Supplier Review Package

Worksurface DWG check • Lock position • Edgebanding changes

Part 1 — Worksurface DWG Review (23 drawings, 22 received)

订单编号		产品型号	5CWS－M2460－W	部件代号		版本号	1	制图/日期	
系列名称	CON	产品名称	面板	部件名称		页　码	共1张 第1张	审核/日期

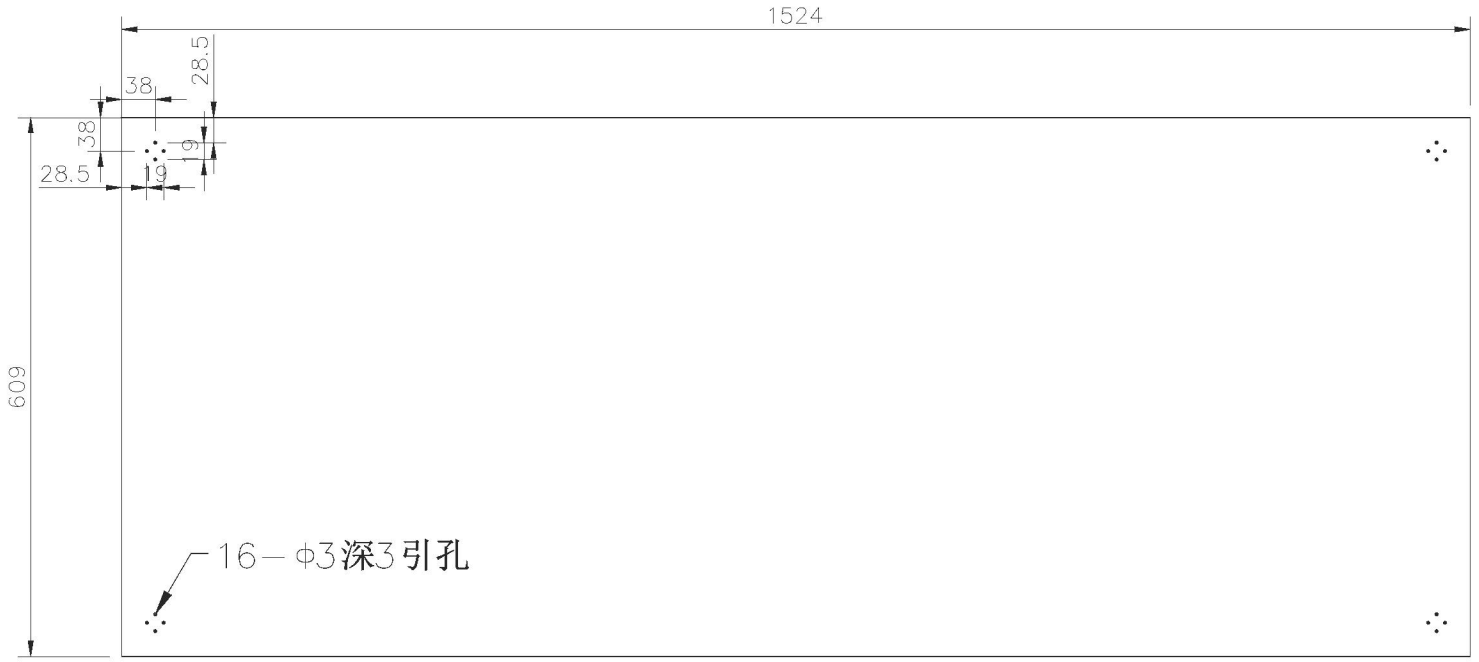
1a. 5CWS-M2460-W: the drawing is wrong. It is a copy of the 5CLWS2460 layout (16 pilot holes, no cutout, no inserts, 1 pc per pack). Please send the correct original for a Group D panel.

订单编号		产品型号	5CWS－M2448－WHV2	部件代号		版本号	1	制图/日期	
系列名称	CON	产品名称	面板	部件名称		页　码	共1张 第1张	审核/日期

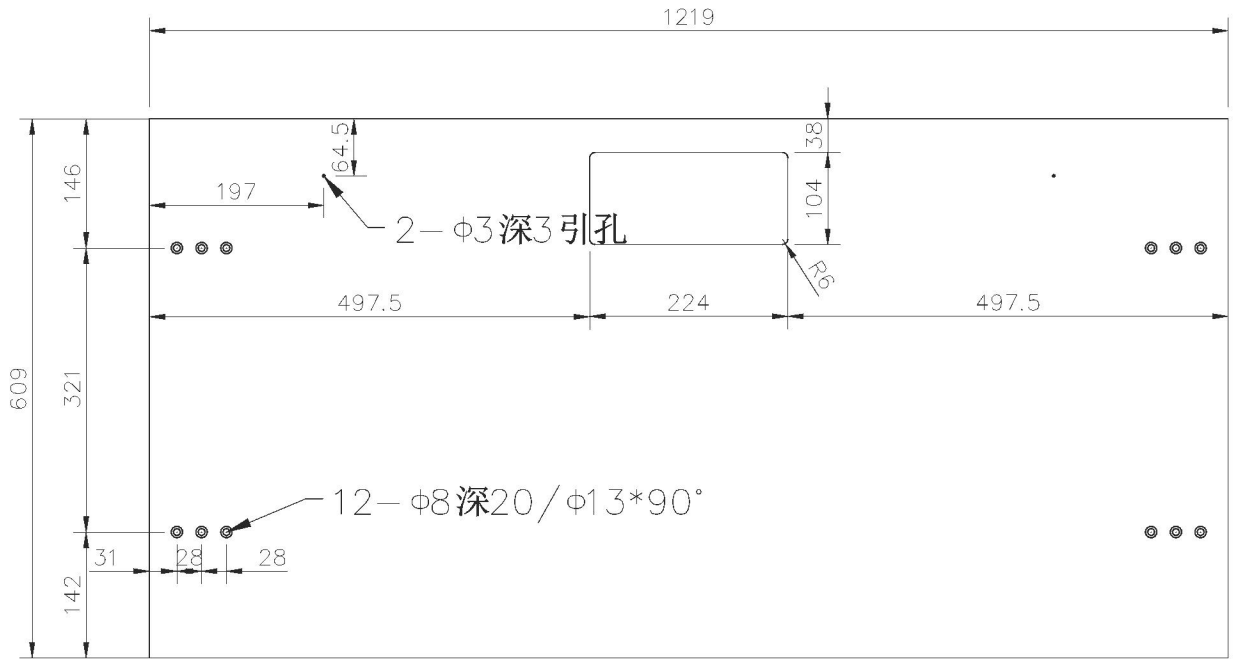
GROUP E — square cable grommet cutout at 389 mm, 12 M6 inserts, 2 pilot holes, 2 pcs per pack					
5CWS-M2448-WHV2	☑	☑	☐!	☑	**Cutout is 224 mm, not 389.** Cutout height is 104 (others 106.5). Notes omit "white" board and the "junction box not included" line.
5CWS-M2460-WHV2	☑	☑	☑	☑	1524 × 609. Cutout 389 × 106.5, centered (567.5 each side).
5CWS-M2472-WHV2	☑	☑	☑	☑	1829 × 609. Cutout 389 × 106.5, centered (720 each side).
5CWS-M3060-WHV2	☑	☑	☑	☑	1524 × 762. Cutout 389 × 106.5, centered (567.5 each side).
5CWS-M3072-WHV2	☑	☑	☑	☑	1829 × 762. Cutout 389 × 106.5, centered (720 each side).
On the drawings: 12 × Ø8 deep 20 / Ø13 × 90° (6 holes each end; rows 146 mm from the top edge, 321 mm apart; pitch 28 mm, 31 mm from the left edge), 2 × Ø3 deep 3 pilot holes, cutout 38 from the top edge with R6 corners, white board, junction box not included, 3 mm same-color edgebanding, 2 pcs per pack.

1d. 5CWS-M2448-WHV2: the drawing shows a **224 mm** cutout (104 mm tall), but Group E is supposed to be 389 mm (106.5 mm tall). 224 mm is the Group D size, and this drawing matches 5CWS-M2448-W. Is it the wrong drawing, or is the 24x48 intentionally different? Its notes also omit "white" board and "junction box not included". Confirm which is correct.
